**MINUTES OF THE PLANNING AUTHORITY MEETING
OF THE BRIGHTON COUNCIL HELD
IN THE COUNCIL CHAMBERS, COUNCIL OFFICES, OLD BEACH
AT 5.30 P.M. ON TUESDAY, 2 JULY 2024**

6.1 Development Application DA 2024/0061 - Multiple Dwellings x 53 (51 new, 2 existing) at 24B & 38 Jetty Road, Old Beach

Figure 4: Building Envelope Diagram 1 showing envelope protrusion for units 23 and 24, and eaves excluded by 8.4.3 A3 from southern boundary (source: Application documents)

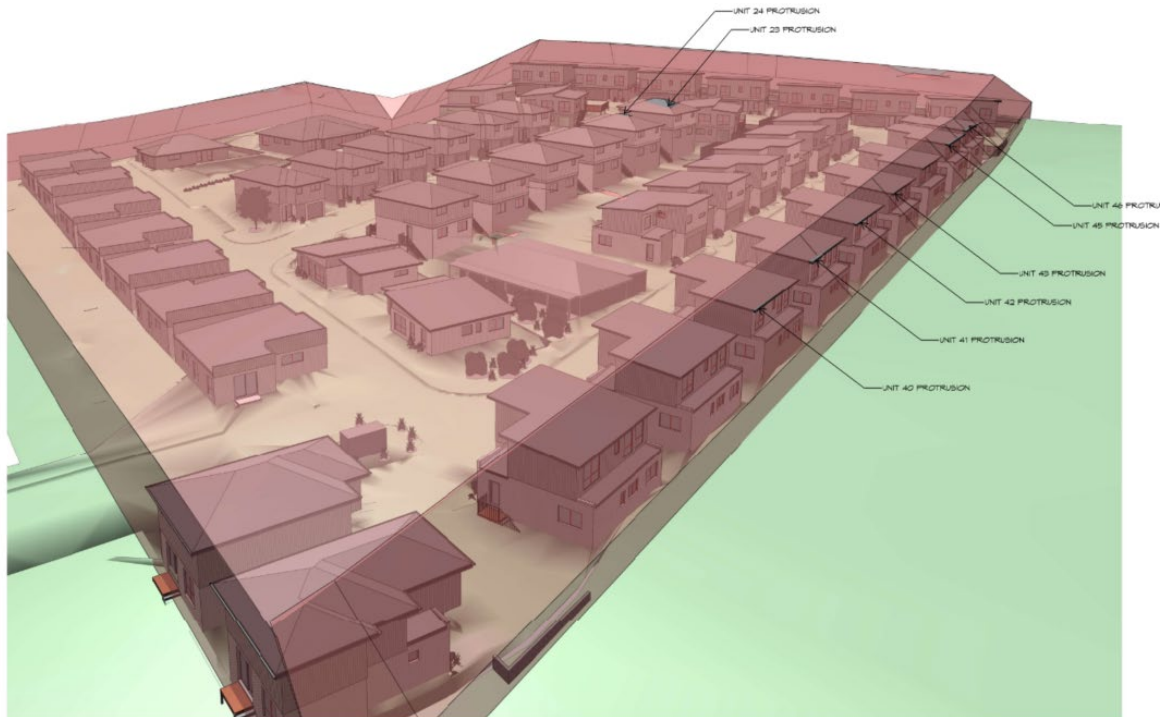
The proposal exceeds the building envelope for dwellings 21, 23 and 24, located in the centre of the site, whilst the protrusions for eaves along the southern boundary (being units 40 – 46) and northern boundary (unit 21) are excluded under 8.4.2 A3. The acceptable solution is not met, and assessment against the performance criteria is relied upon.

Figures 4 and 5 shows the Building Envelope Diagrams which form part of the proposal plans (sheet PD23405-09 Revision 05). The diagrams show the areas located outside of the building envelope.

The applicant has confirmed that it will reduce the height of units 21, 23 and 24, to ensure that all dwellings comply with the Acceptable Solution for building envelope required by 8.4.2. A3, and has requested that a condition be included in any permit requiring amended plans to be submitted to Council for approval, prior to commencement of any works or issue of any approvals required pursuant to the *Building Act 2016*.

- (a) the height of dwellings 21, 23 and 24 lowered to comply with the building envelope prescribed by 8.4.2 A3 of the Tasmanian Planning Scheme – Brighton.
